MODIFICATION RECOMMENDED

MSOX3014A-03

S E R V I C E N O T E

MSOX3014A – Oscilloscope, Mixed Signal, 4+8 Channel,
100MHz

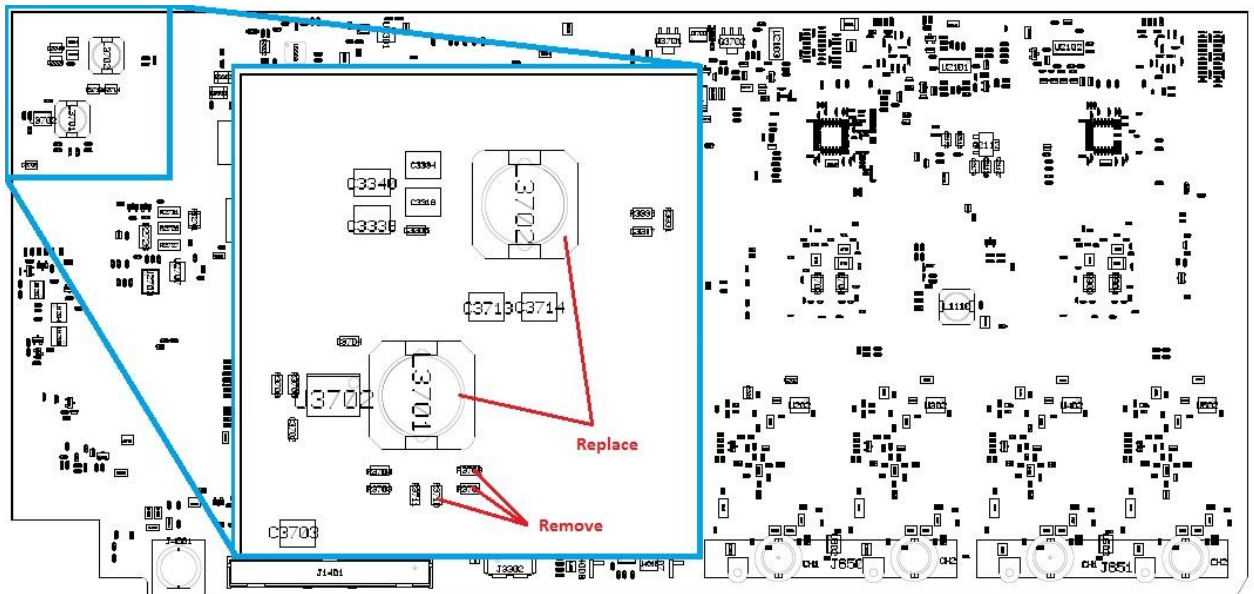
With the oscilloscope power turned on and while under normal operation, the unit emits a hissing noise.

2. As the picture indicates, remove the three resistors (0699-7209, 1 Ohm) located at R3701, R3709, and R3710. They are not to be replaced.
3. Remove as well the two inductors (9140-6474, 100uH) located at L3701 and L3702 and replace them with inductors with part number 9140-6151 (68 uH).
4. Re-assemble to the point where the unit could be powered up to verify that the hissing is indeed gone. If the hissing is not gone, please, check modifications.
5. When the hissing is gone, put oscilloscope back together.
